ASOS MODIFICATION NOTE 47 (for Electronics Technicians)

SUBJECT : Acquisition Control Unit (ACU) Memory Firmware Version 2.60
Data Collection Package (DCP) Boot Erasable Programmable
Read Only Memory (EPROM) Version 1.90

PURPOSE : Firmware upgrade for the Automated Surface Observing System
(ASOS) Operational Load.

TIME REQUIRED	:	4 hours
EFFECT ON OTHER INSTRUCTIONS	:	EHB-11, Section 3.6, this modification note supersedes Modification Note 38.
AUTHORIZATION	:	This modification is authorized by ECP E98SM05F208A
VERIFICATION STATEMENT	:	This modification has been tested for operational integrity at the sites listed in appendix A.

FIGURE 3

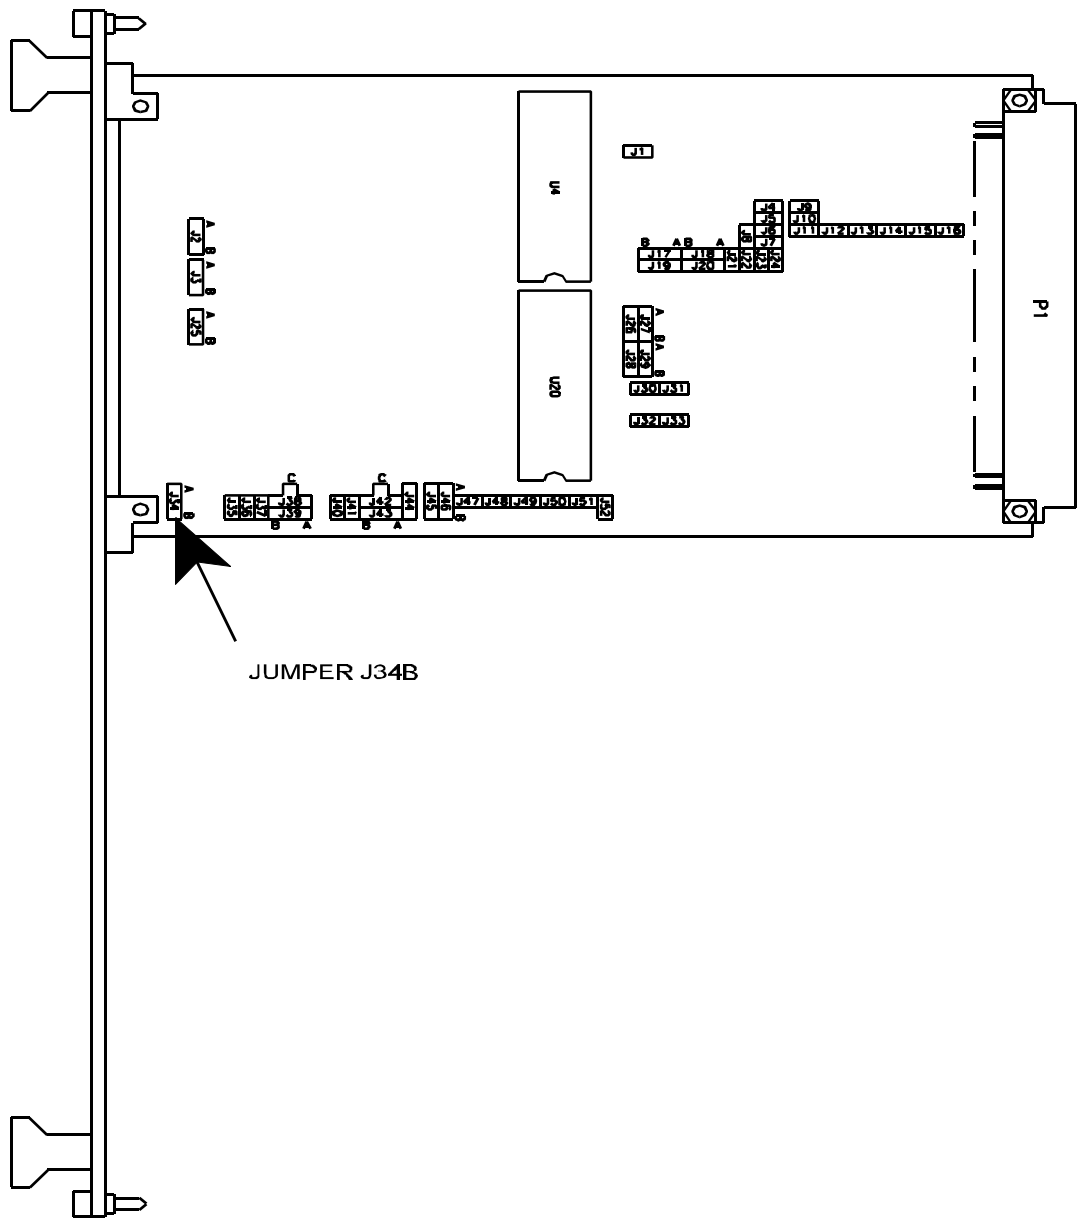
5. Disconnect jumper J22. This action will remove the battery power from the memory board and is necessary to 'cold boot' the system. (Refer to figure 3 for jumper location.)

7. Using the IC extraction tool, remove the U7 EPROM from the front of the board slide. Carefully lift up on U7 to remove it from the socket as evenly as possible. After U7 is removed from the socket, place in a conductive foam or on some other static-free surface. (Refer to Figure 3 for IC locations.)
8. Repeat step 7 for the removal of the following ICs: U8, U17 and U21.
9. Remove the new EPROM ICs, for V2.6, from the protective package and insert them into the memory board sockets in accordance with the following chart. Using the IC insertion tool and ensuring that the EPROMs are installed with pin 1 (as identified by notch in top of IC) oriented toward board connectors P1 and P2, as shown on figure 3, press the EPROMs into their respective sockets.

<u>IC socket</u>	<u>IC part number</u>
U8	62828-45002-1
U17	62828-45003-1
U7	62828-45004-1
U21	62828-45005-1

FIGURE 1

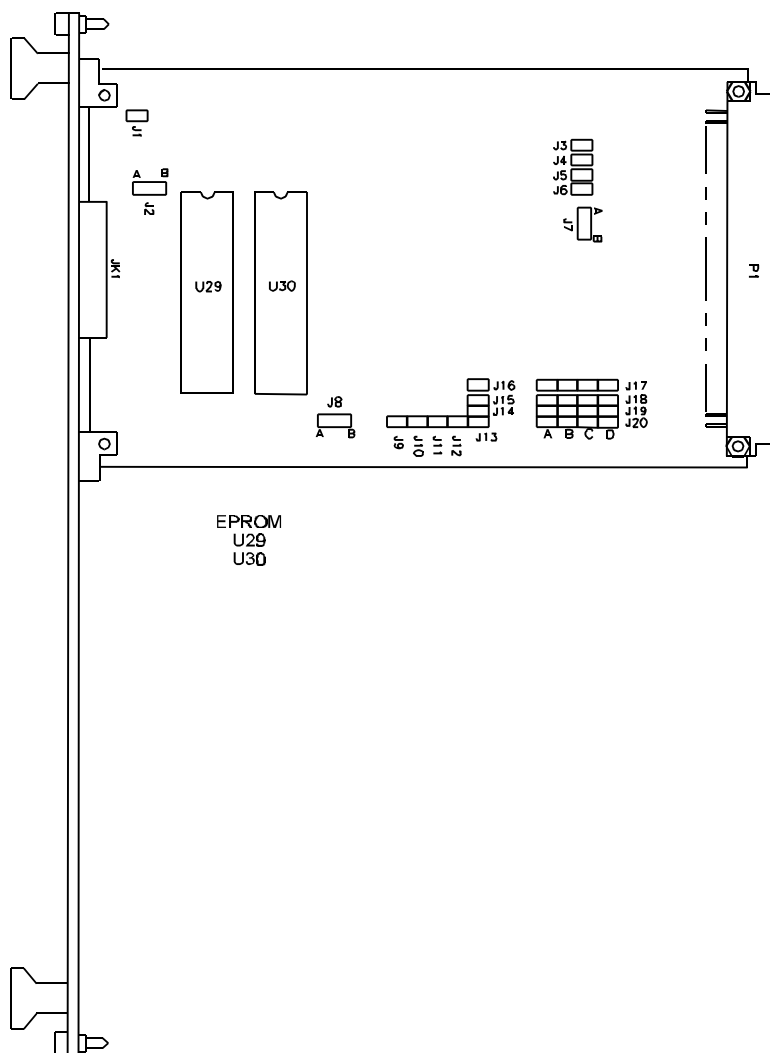
6. Disconnect the J34B connector. This will remove battery power from the memory board which is necessary to 'cold boot' the system. Set the memory board and jumper aside in a location safe from physical or ESD damage. (Refer to figure 1 for jumper location.)

12. Reinstall jumper J34B on the memory board that was disconnected in step 6.
13. Holding the DCP memory board by the handles, position the board with the component side facing to the right and carefully slide the board into the card rack on its guides. Align the board with the rear connector and press into place.

FIGURE 2

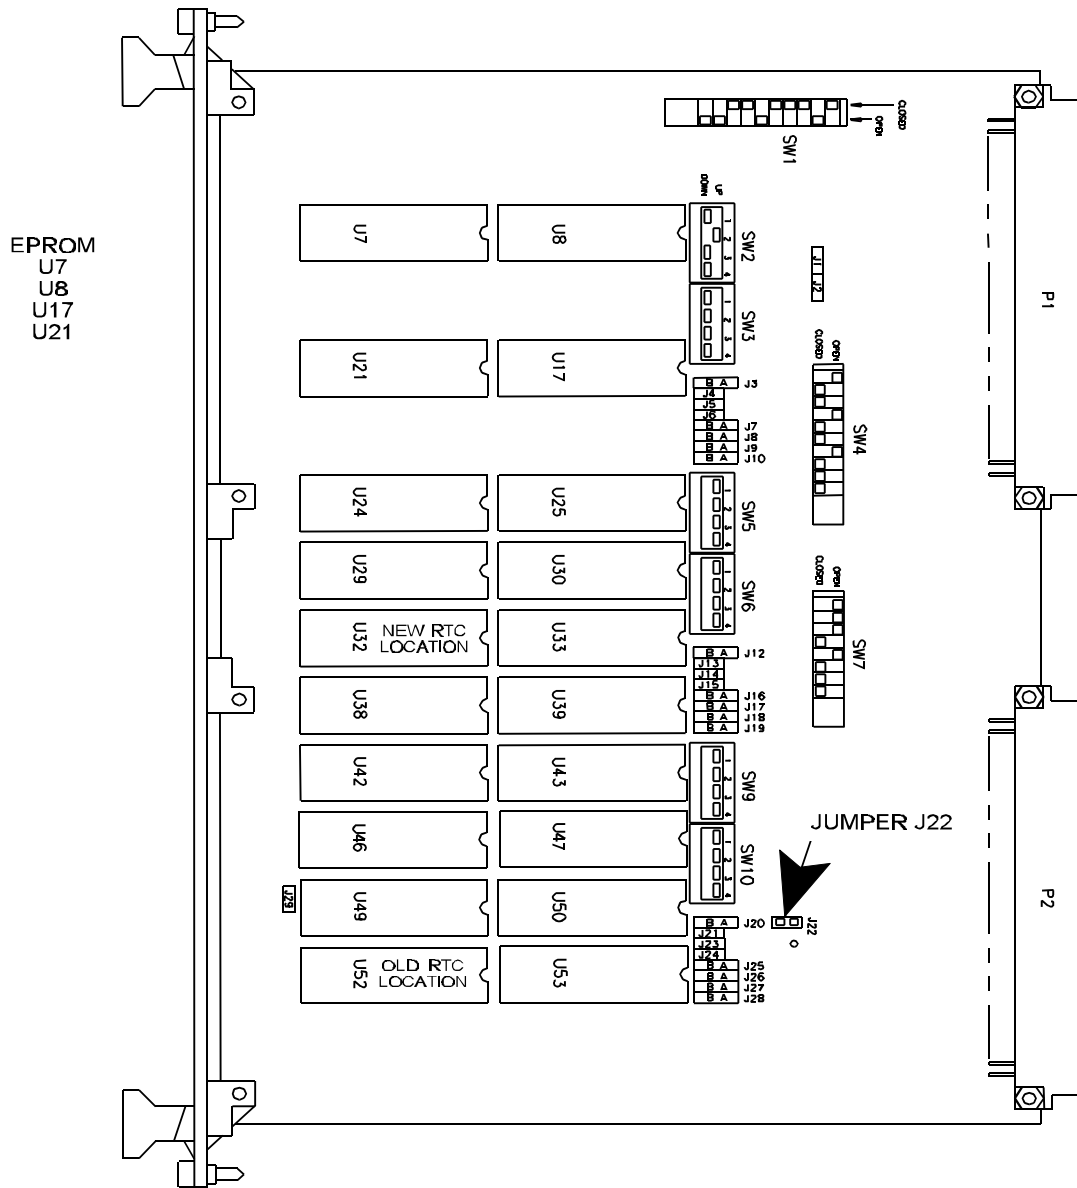
10. Using an IC extractor, remove the U29 and U30 EPROMs from the DCP CPU printed circuit boards 2A1A2A1 (and 2A1A2A2 if installed). Place the removed ICs in a conductive foam or on some other static-free surface. (Refer to figure 2 for IC locations.)
11. Remove the new EPROM ICs from the protective package and insert them into the DCP CPU board sockets in accordance with the following chart. Using the IC insertion tool and ensuring that the EPROMs are installed with pin 1 (as identified by notch in top of the IC) oriented toward the board connector, press the EPROMs into their respective sockets.

<u>IC socket</u>	<u>IC part number</u>
U29	62828-45018-1 Version 1.90
U30	62828-45019-1 Version 1.90
